Re: Indian Point Unit 2
Docket 50-247

NL-08-101

**SUBJECT: Proposed Changes to Indian Point 2 Technical Specifications
Regarding Diesel Generator Endurance Test Surveillance**

- 1: Analysis of Proposed Technical Specification Changes Regarding Diesel Generator Endurance Test Surveillance
- 2: Markup of Technical Specification Page for Proposed Changes Regarding Diesel Generator Endurance Test Surveillance

FIGURE 35 - TEST 3 LOAD DUTY CYCLE LOWER PHENOLICS

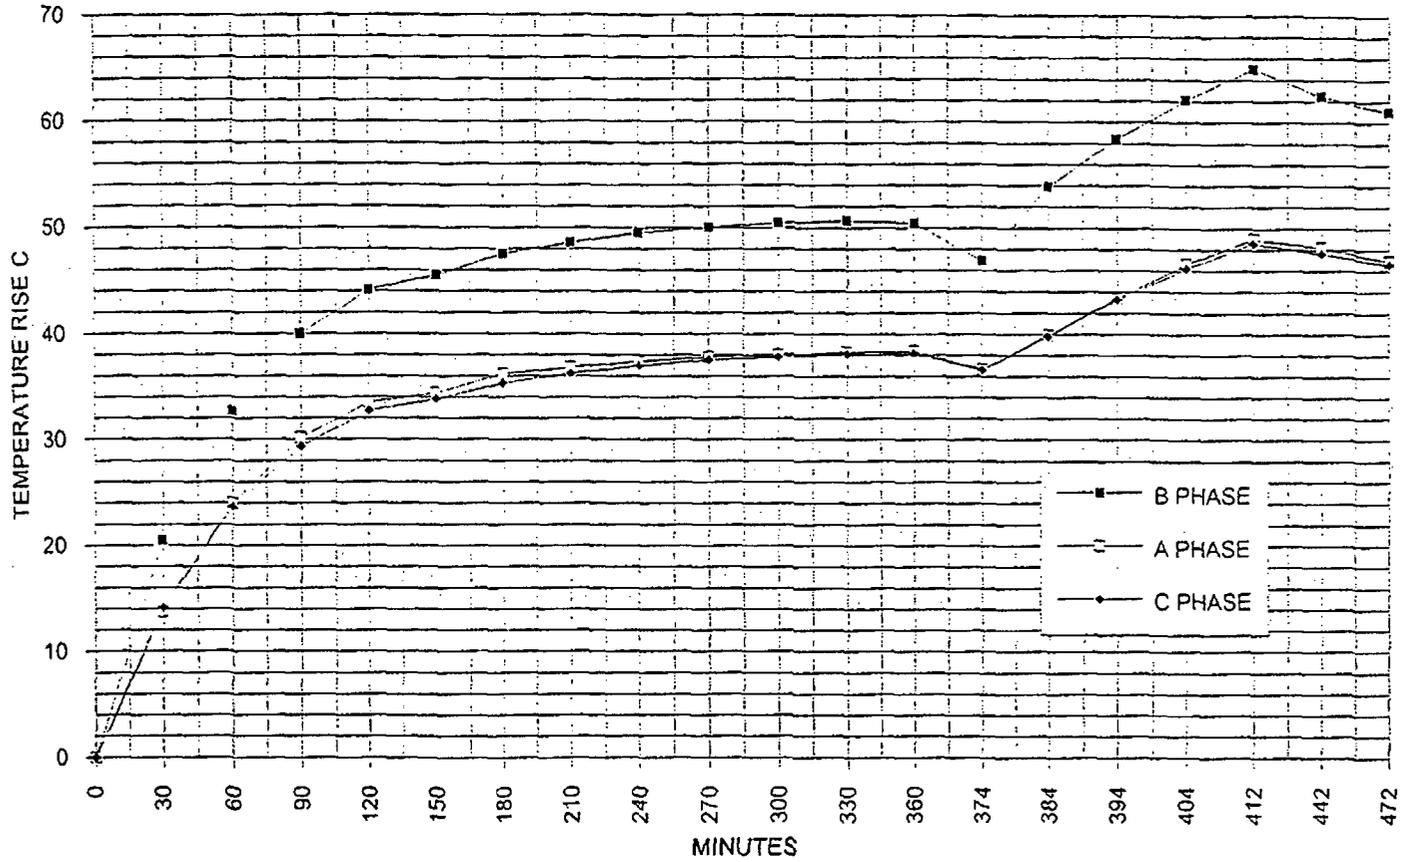
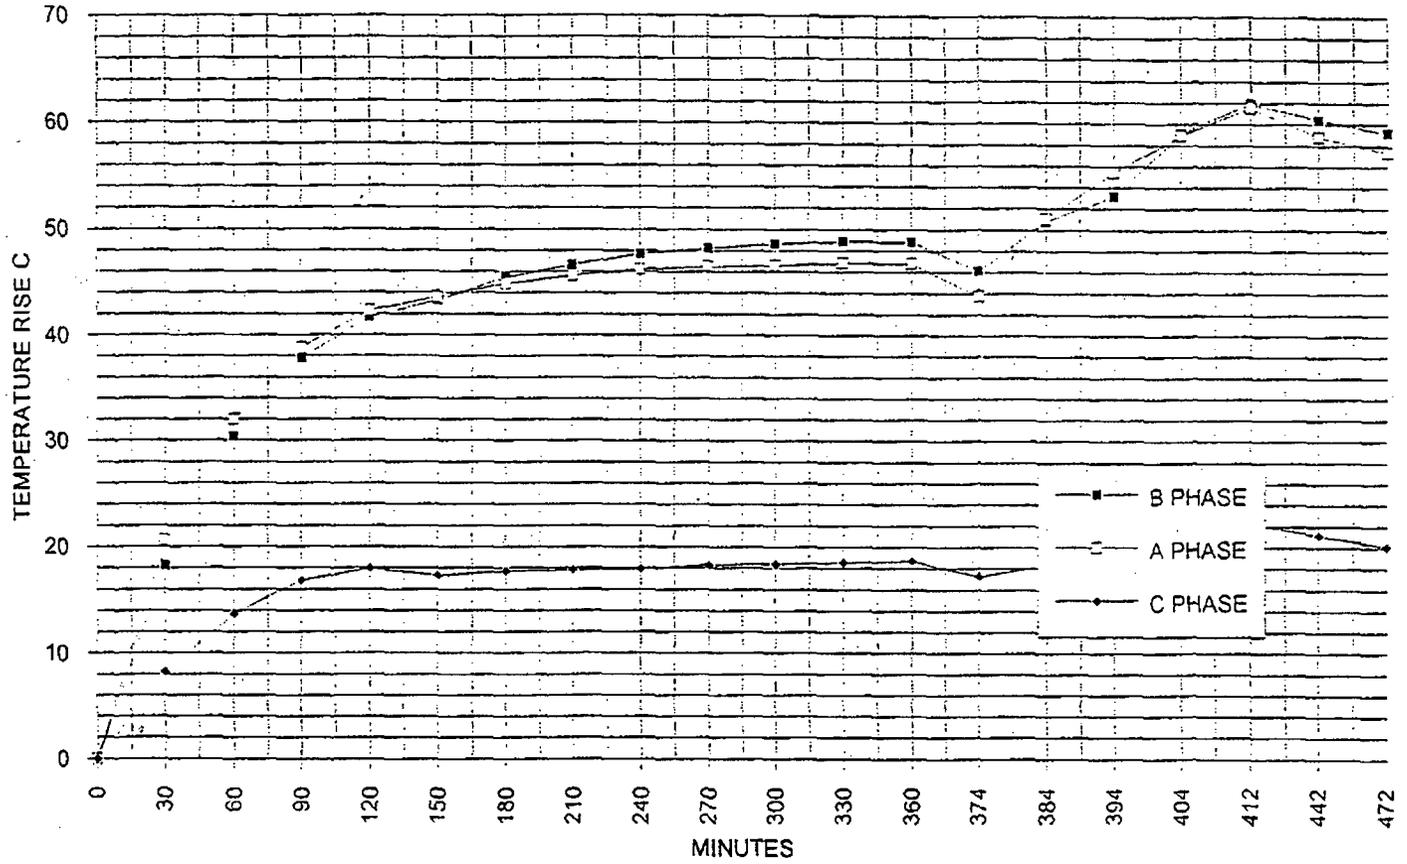
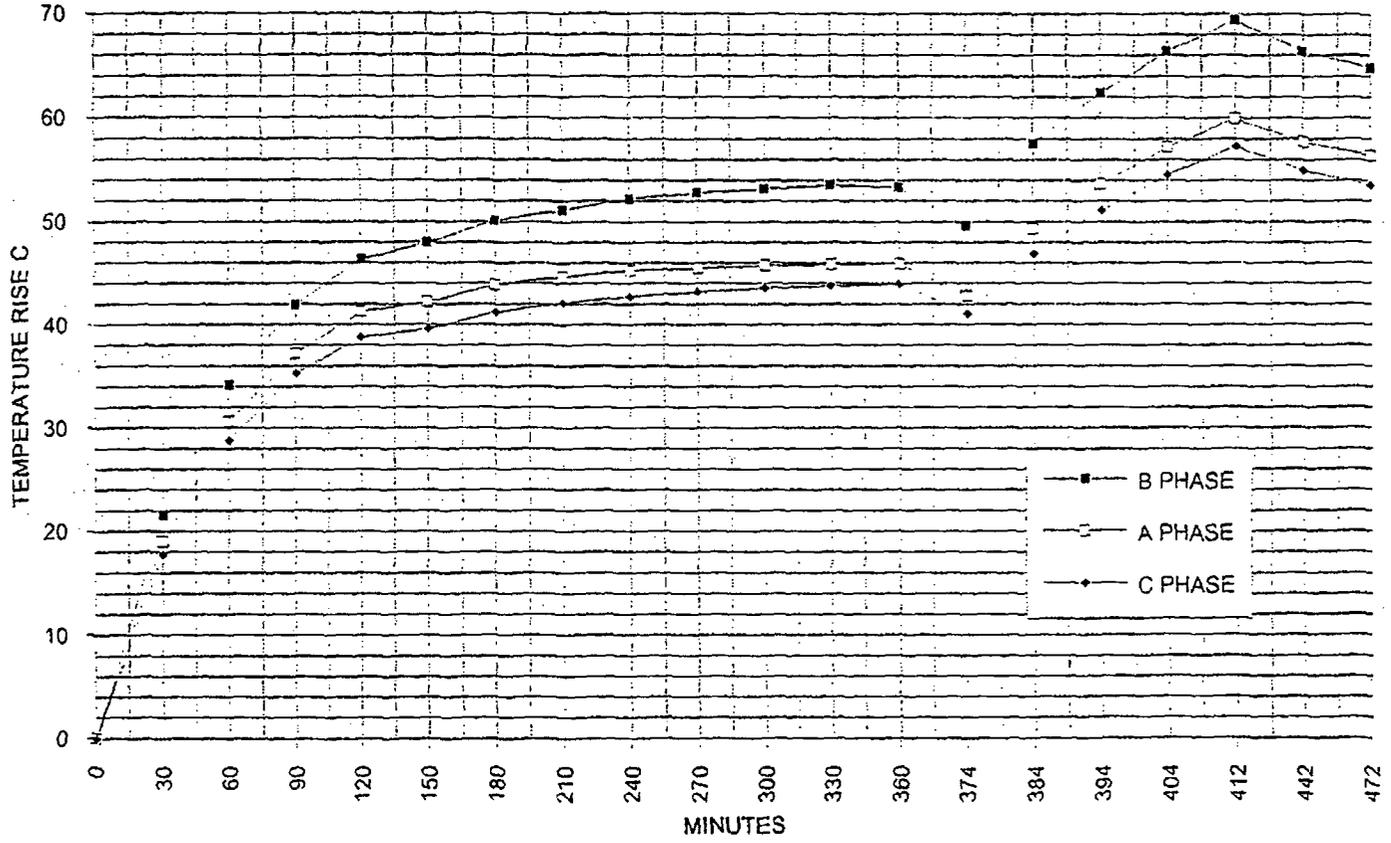
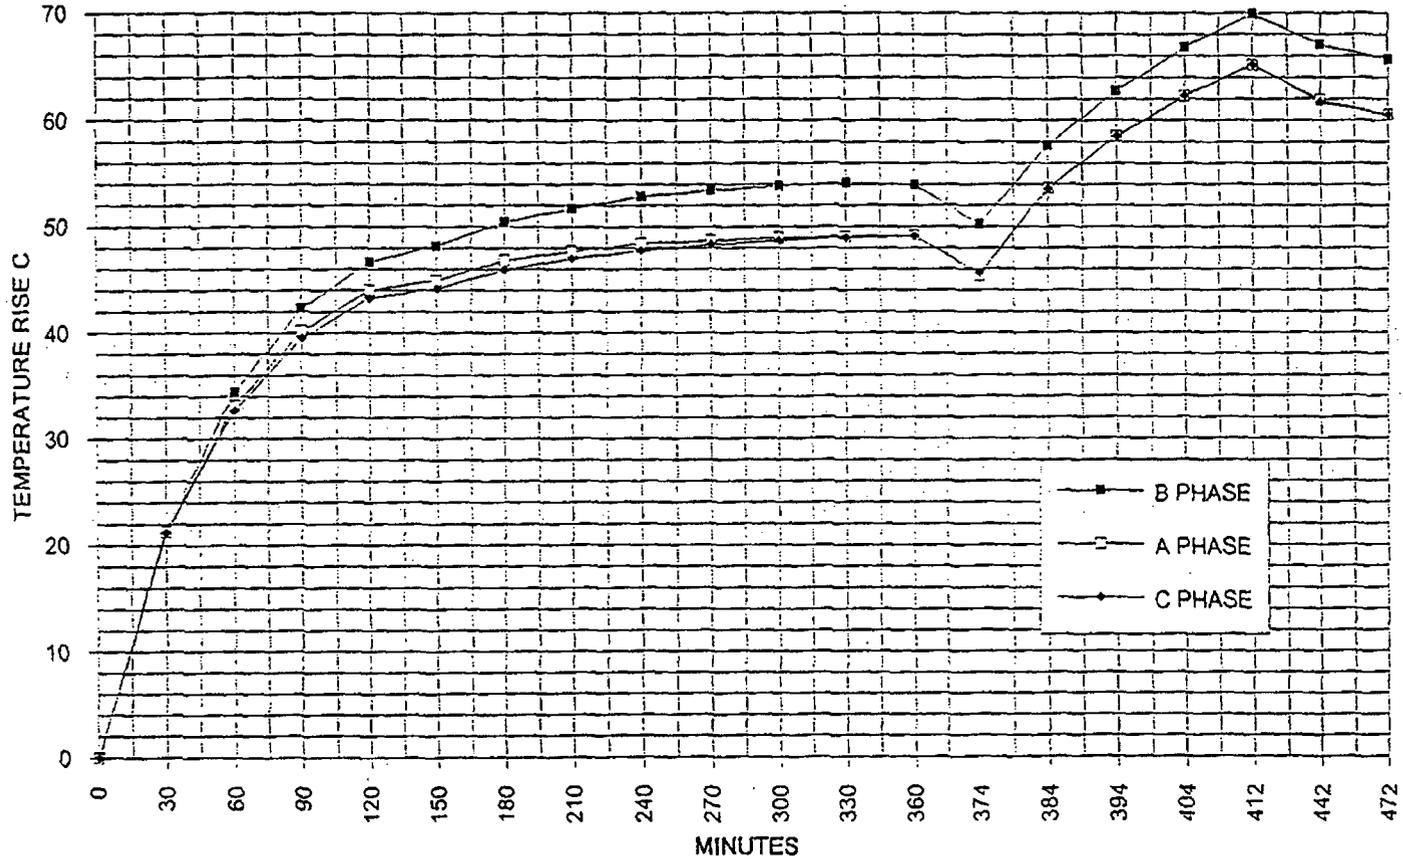
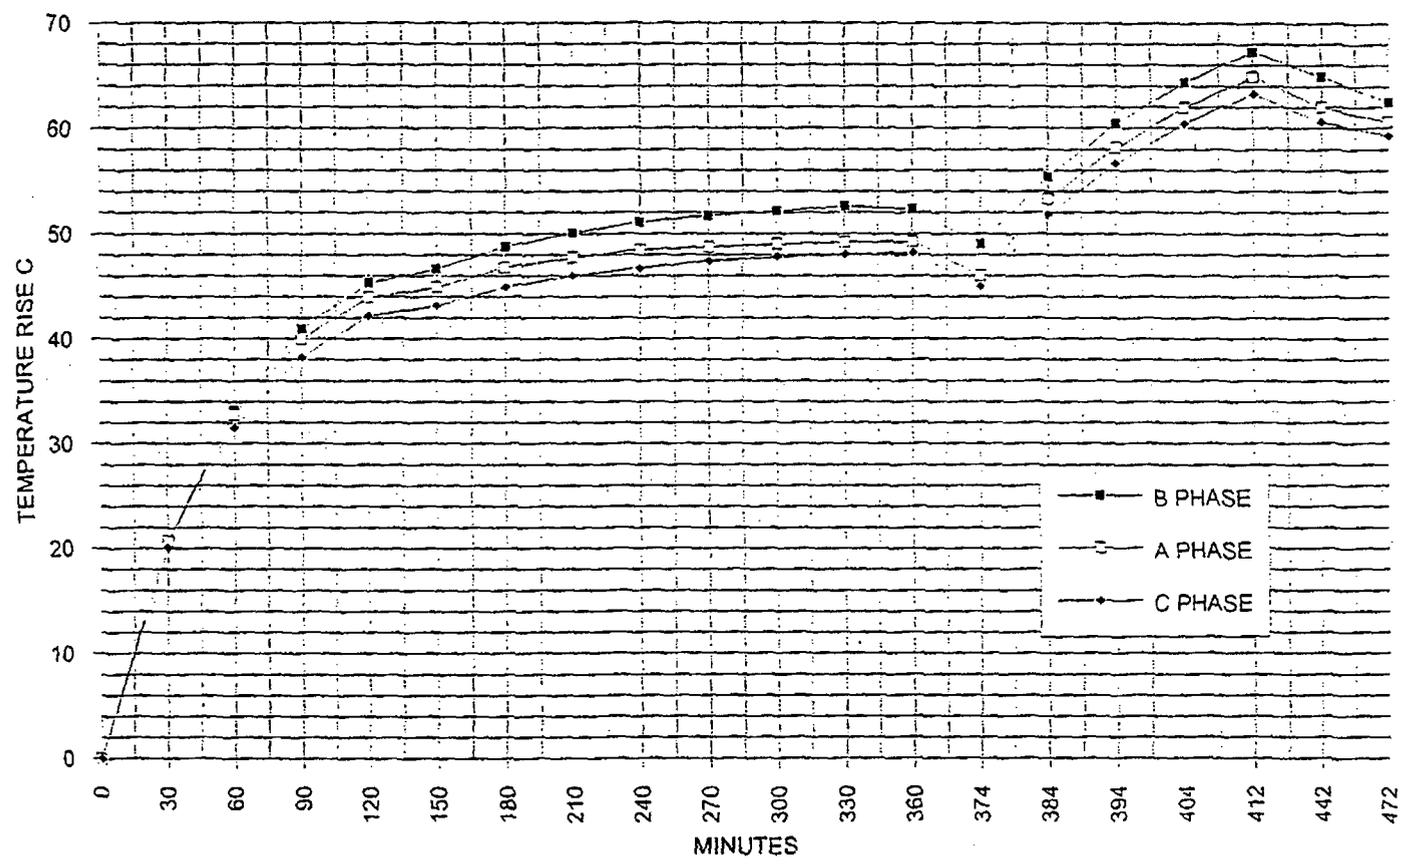
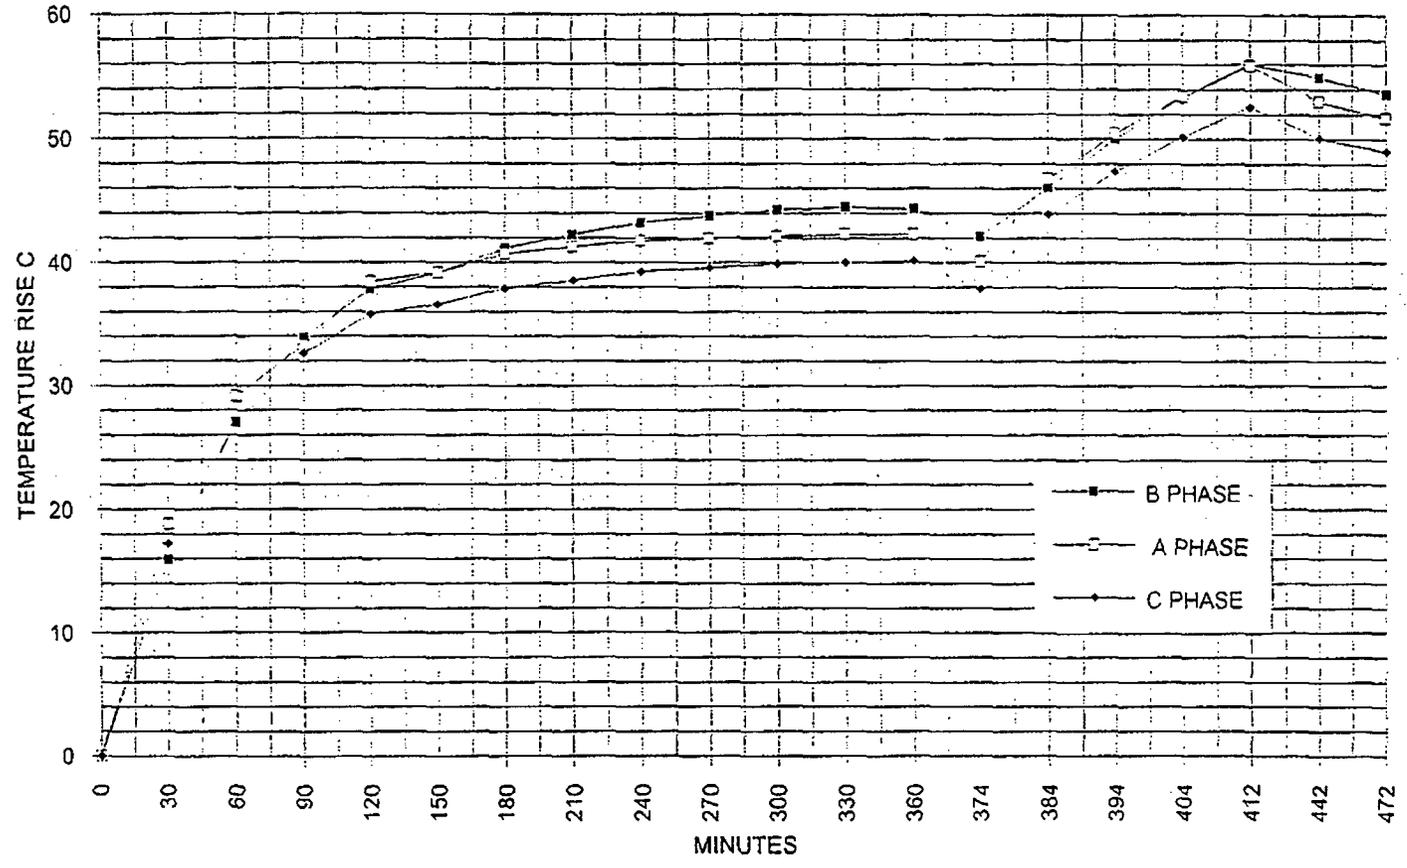
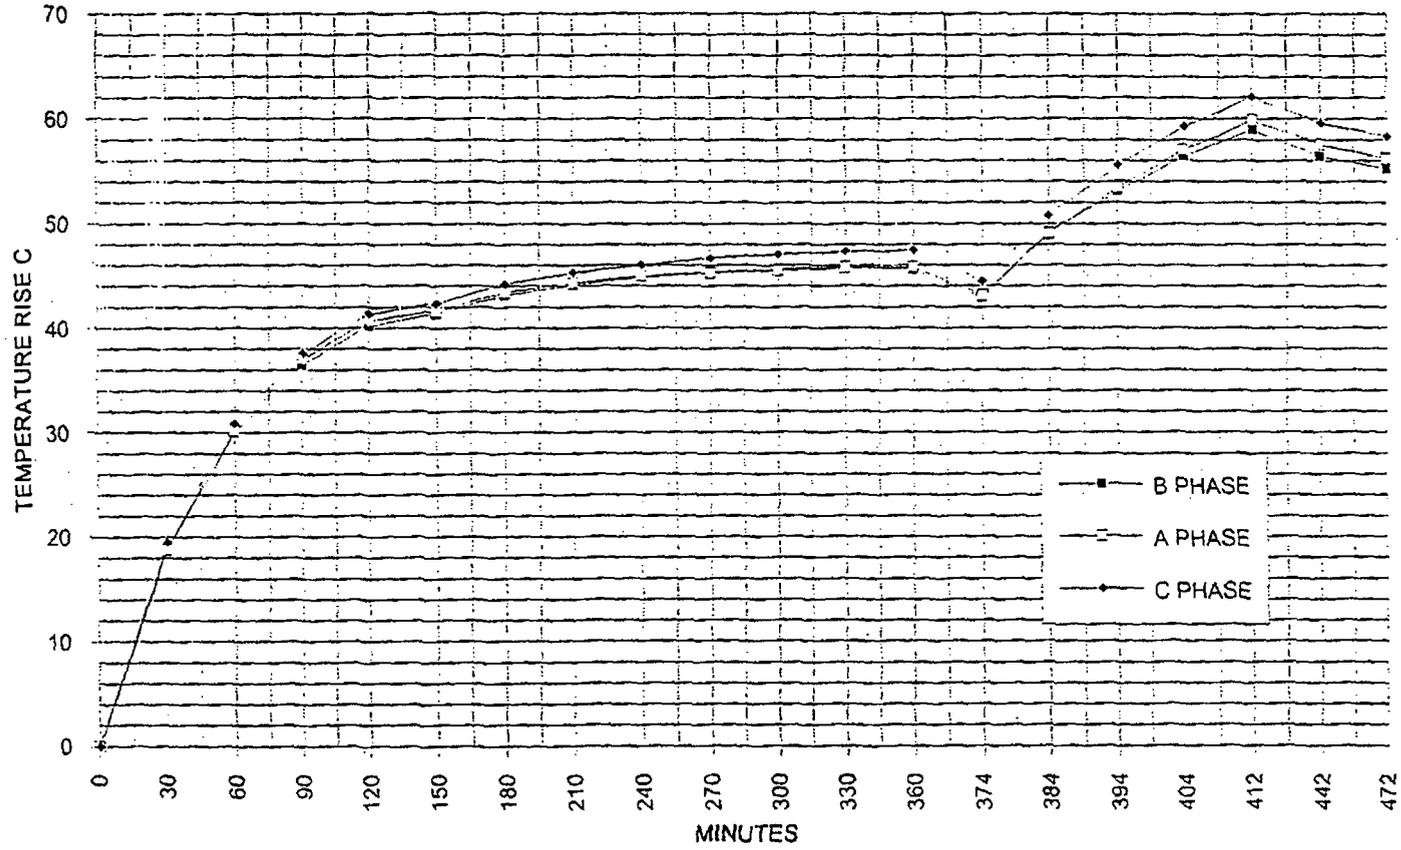
Figures 35 through 42 show the same test data as figures 27-34. The data indicates that with the breaker pre-loaded and stabilized at 2500 amperes, it can sustain 3300 amperes for 48 minutes. The reason for the difference is that during testing, there was another test set up in the area which failed causing a loss of power for approximately 30 seconds. Even with this minor anomaly, the test data is consistent with previously obtained data.
